Amendments to the Drawings:

REMARKS

Appln. No. 10/759,899
Amdt. Dated April 11, 2006
Reply to Office Action of November 15, 2005
Annotated Sheet Showing Changes

Fig. 3b (Prior Art) + added per the examiner's request

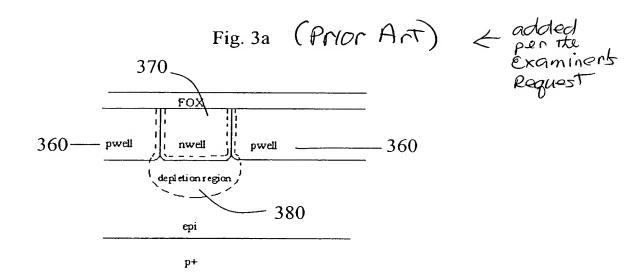
Figures 3a-3b should be designated by a legend such as --Prior Art-- because only that which is old is illustrated. Corrected drawings in compliance with 37 CFR 1.121(d) are attached.

* Changed to correctly reflect the specification
